INDEX PLAN FOR RCC 3RD PODIUM FLOOR SLAB
SCALE 1:100

OPTION 02_P3 PLAN

INDEX PLAN FOR RCC 2ND PODIUM FLOOR SLAB
SCALE 1:100

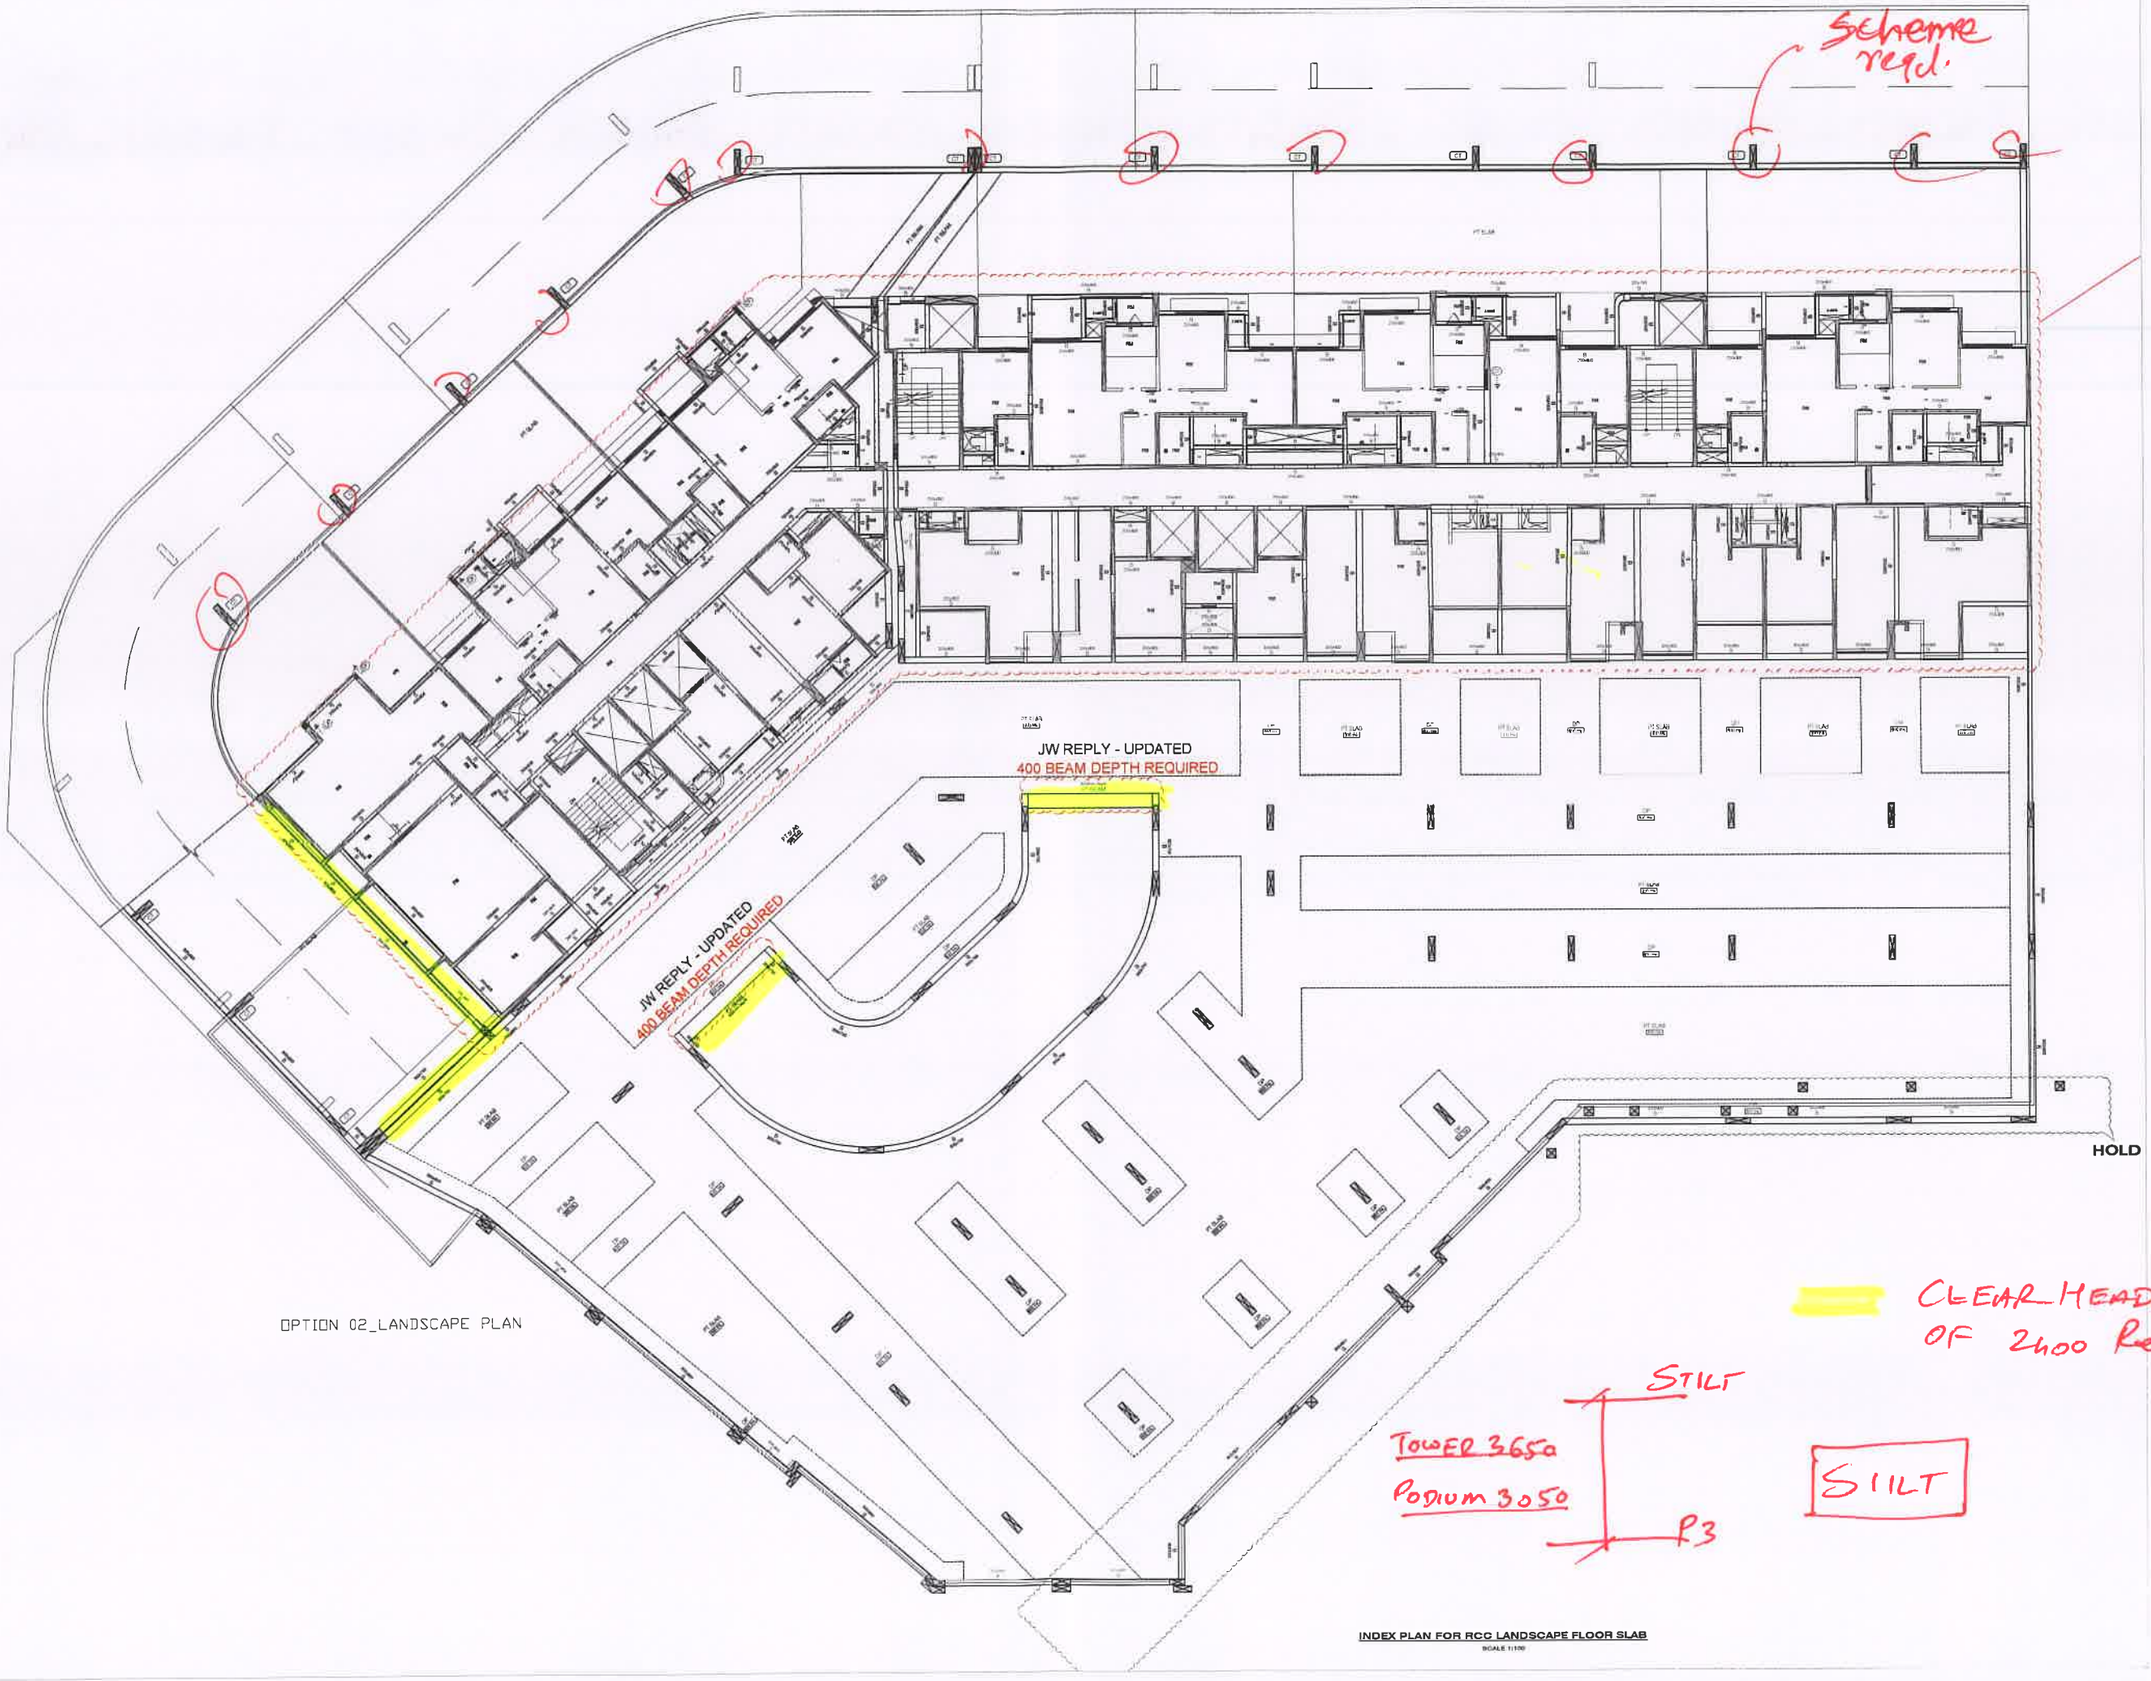
LAB NOT POSSIBLE

CLEAR HEADROOM OF 2400 Reqd.

L BEAMS COMING IN
G PROFLE NEEDS TO
)0 DEPTH
PLY - UPDATED

BEAM DEPTH 400MM REQUIRE

6.00 M. WIDE DRIVE-WAY
6.00 M. WIDE DRIVE-WAY
6.00 M. WIDE DRIVE-WAY
3.00 M. WIDE DRIVE-WAY
3.00 M. WIDE DRIVE-WAY
6.00 M. WIDE DRIVE-WAY
JW REPLY - UPDATED
400 BEAM DEPTH REQUIRED
6.00 M. WIDE DRIVE-WAY
6.00 M. WIDE DRIVE-WAY
6.00 M. WIDE DRIVE-WAY
6.00 M. WIDE DRIVE-WAY
5.50 M. WIDE DRIVE-WAY
6.00 M. WIDE DRIVE-WAY
6.00 M. WIDE DRIVE-WAY

JW REPLY - UPDATED
400 BEAM DEPTH REQUIRED

OPTION 02_P2 PLAN

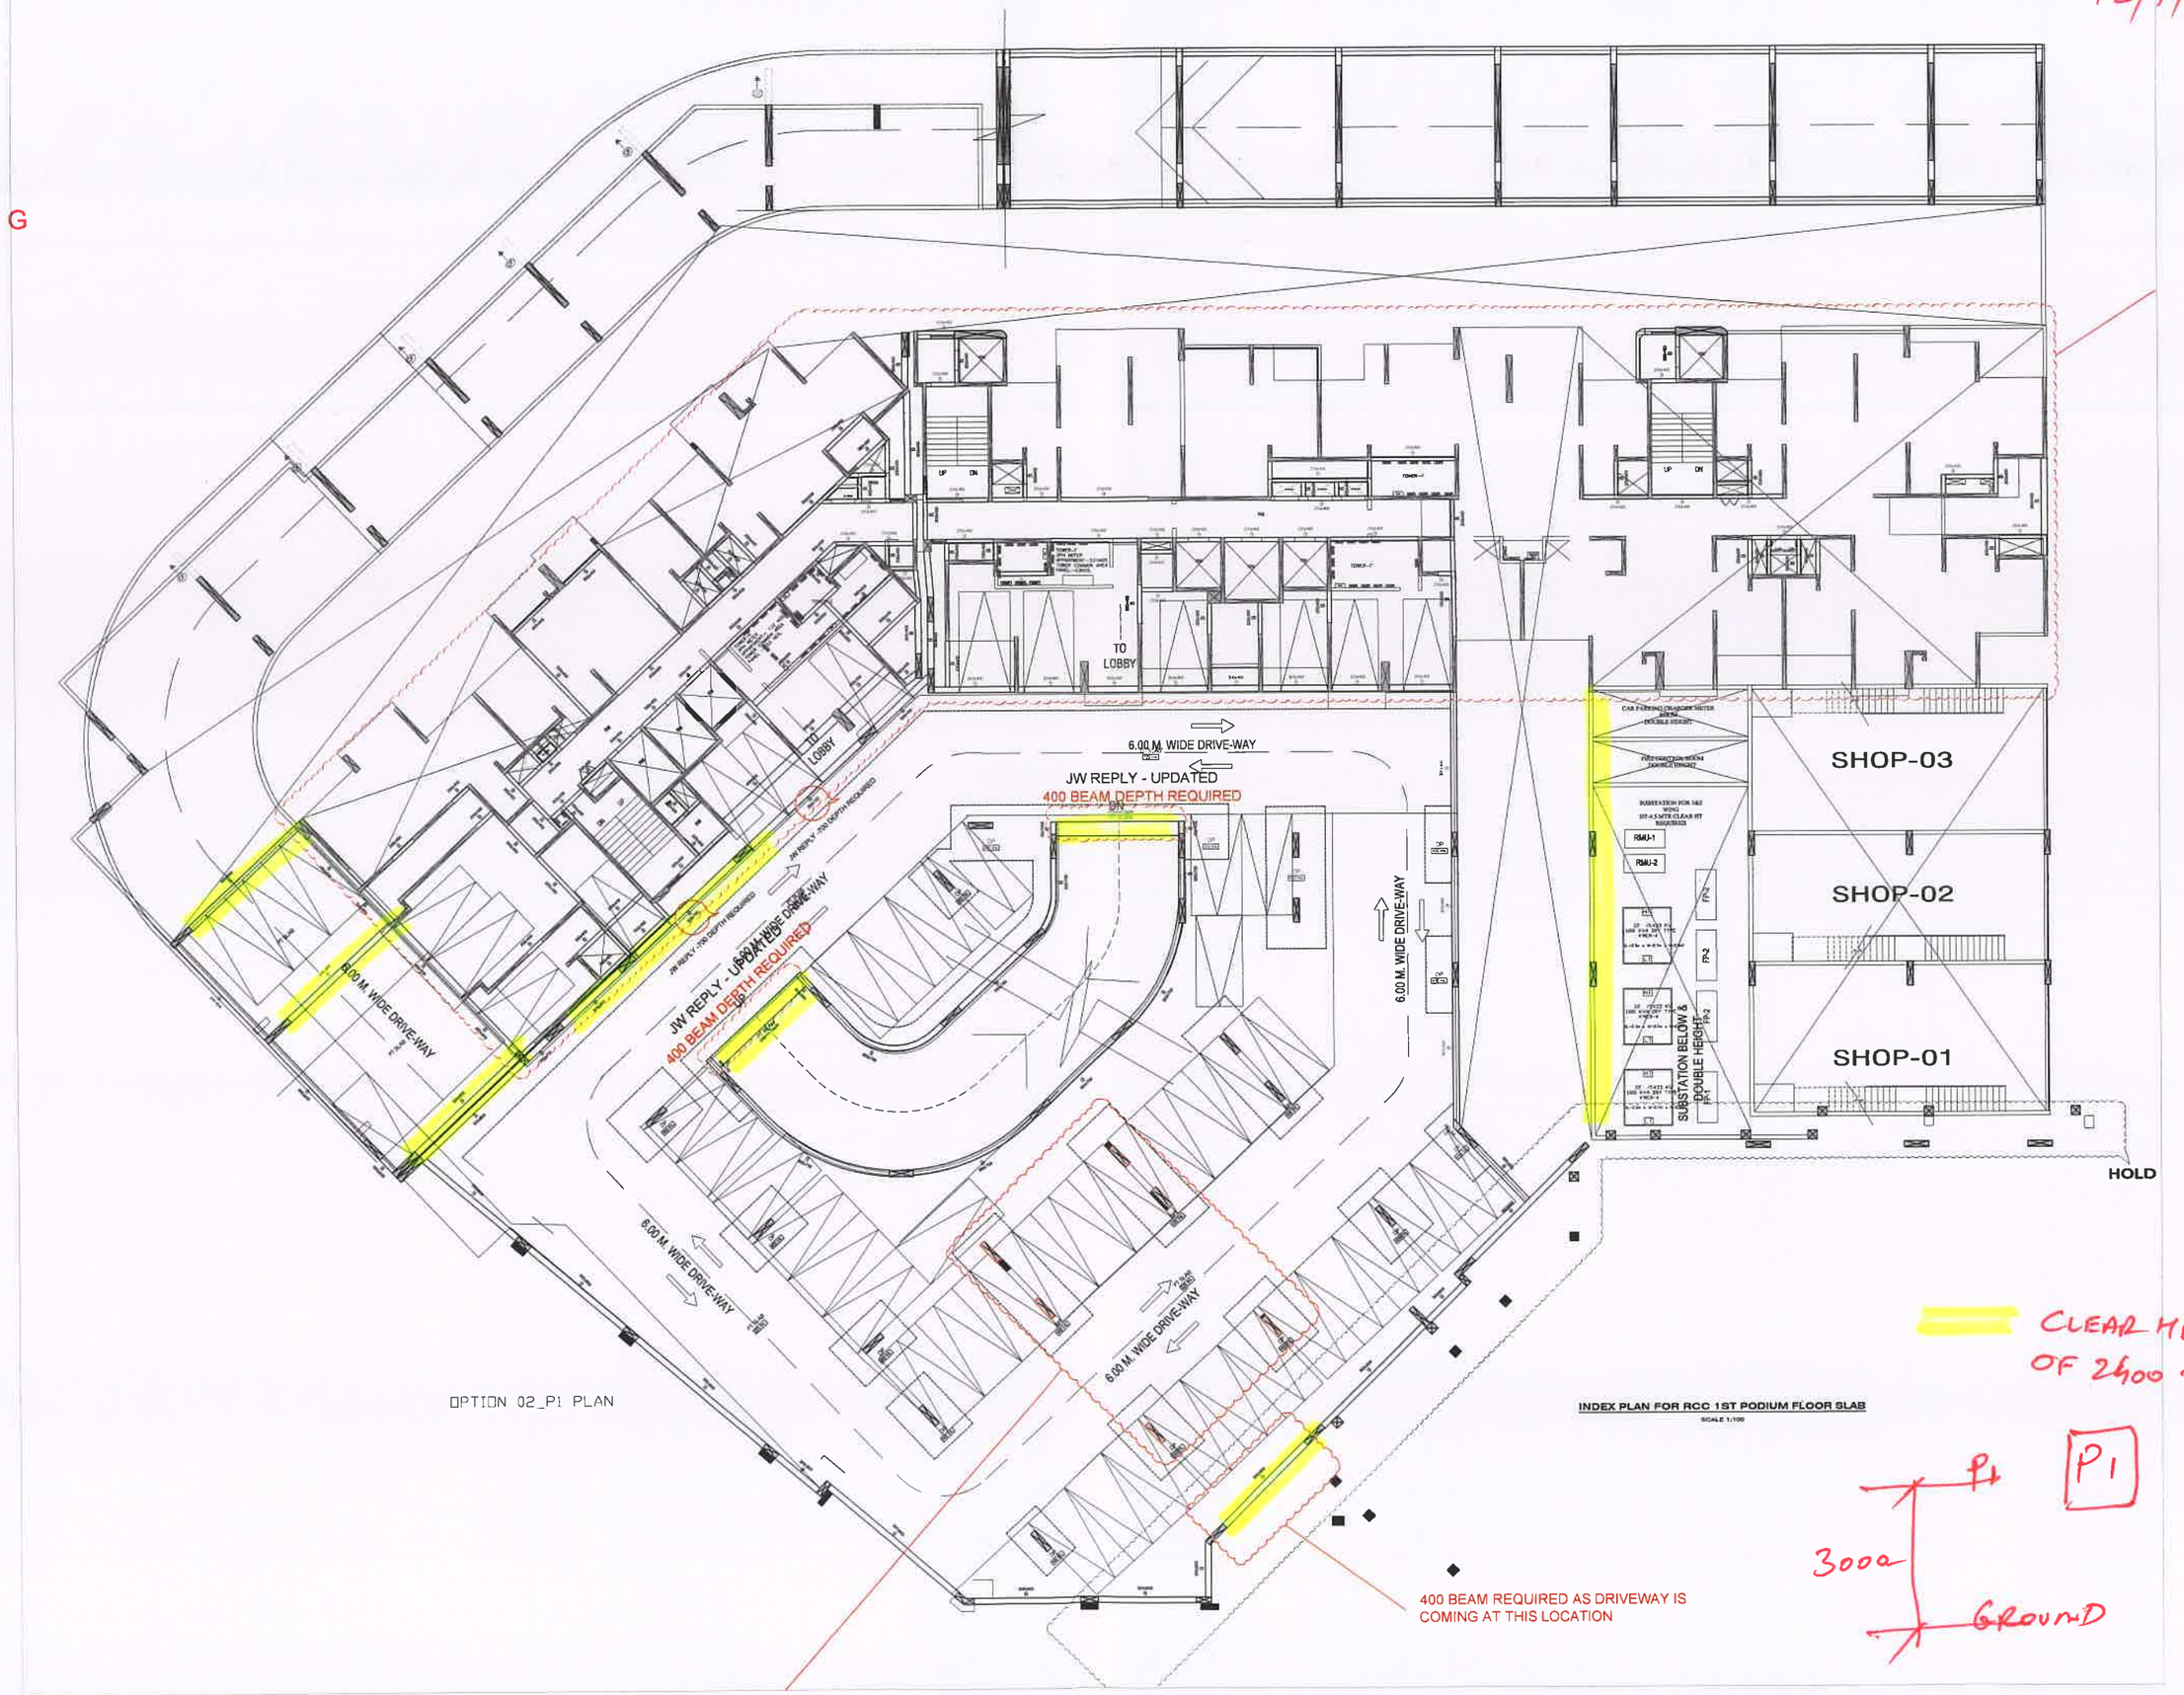
CLEAR HEADROOM OF 2400 Required

MENTION P.T. BEAM SIZE

Lift to be considered.

CLEAR HEADROOM OF 2400 mm Reqd.

JW REPLY - UPDATED
400 BEAM DEPTH REQUIRED

JW REPLY - UPDATED
400 BEAM DEPTH REQUIRED
